CLARK COUNTY, NEVADA
BID NO. 603175-13
WINCHESTER CULTURAL CENTER: NEW RESTROOM, SITE LIGHTING & PARKING LOT REHABILITATION

December 13, 2013

ADDENDUM NO. 1

SHEET #
C1.4

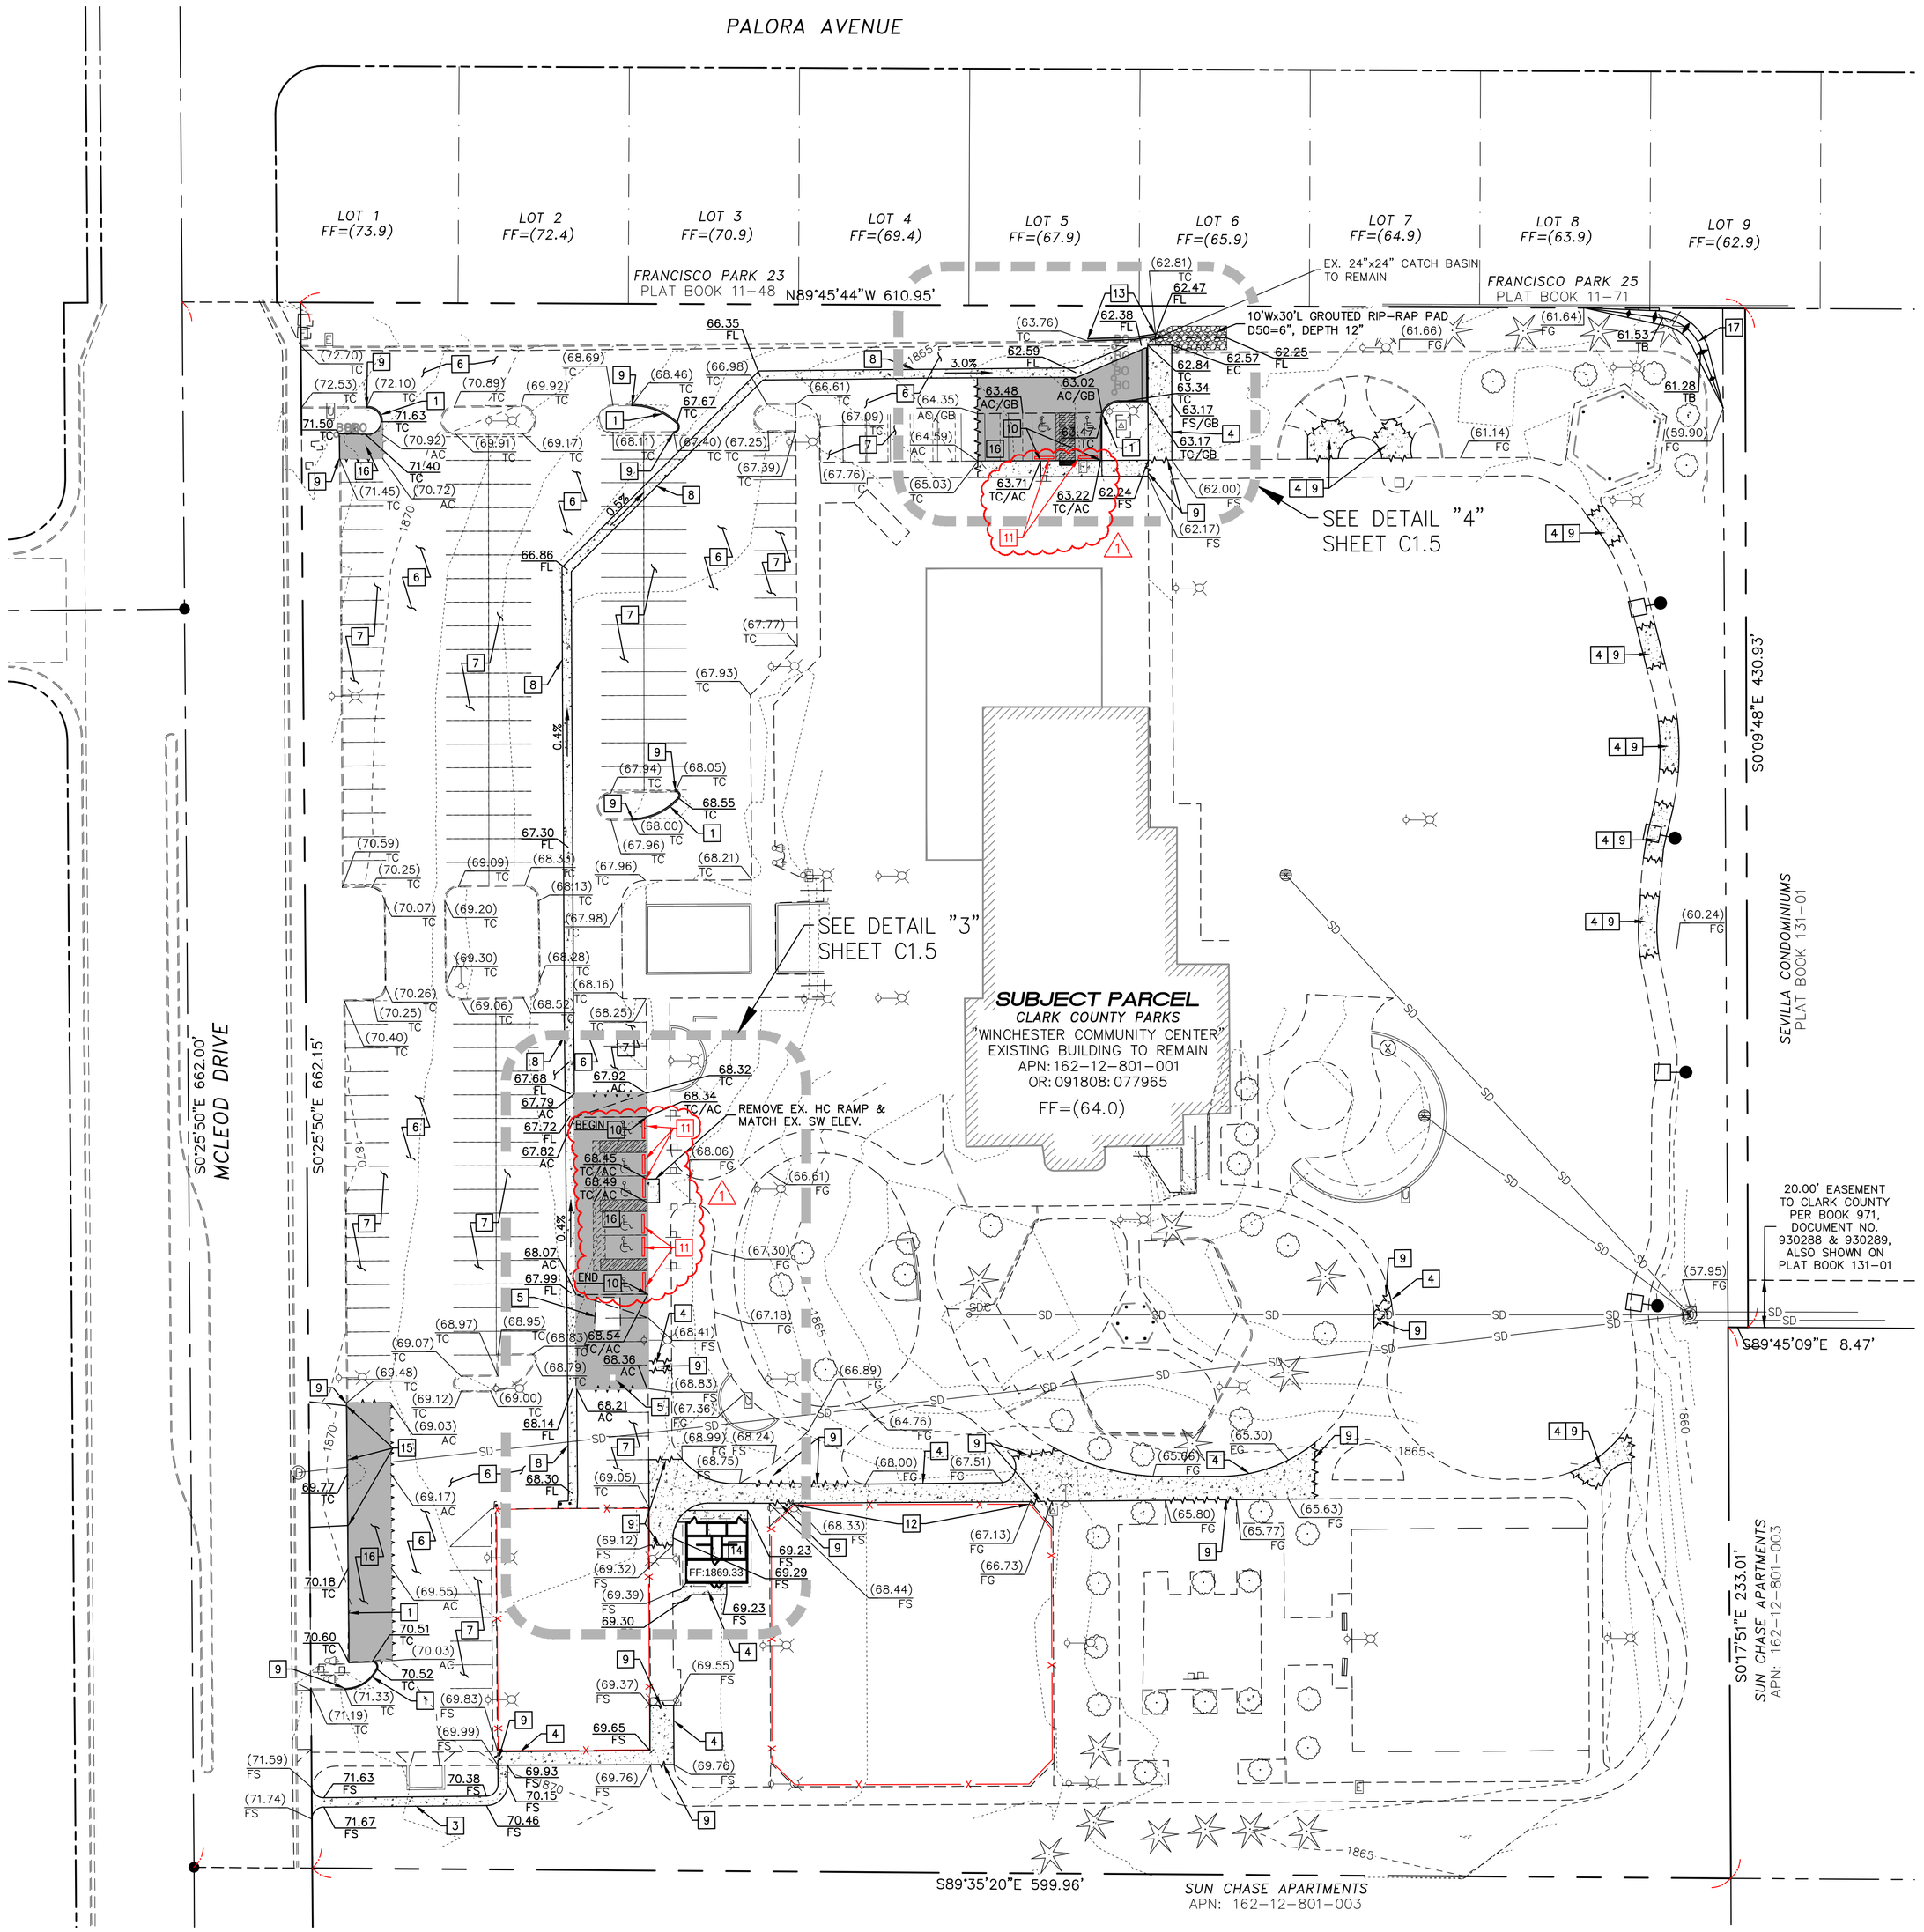
Q10 Sheet C1.4 and C1.5 Note 11 Install Precast Bumper Block, This is not shown on either sheet, can we get a clarification please.

A10 See attached Sheet C1.4 , and sheet C1.5 redlines.

REV#	REV. DESCRIPTION	DATE
1	REVISED PARKING BLOCKS PER RFI EMAIL DATED 12/8/2013	12/11/2013
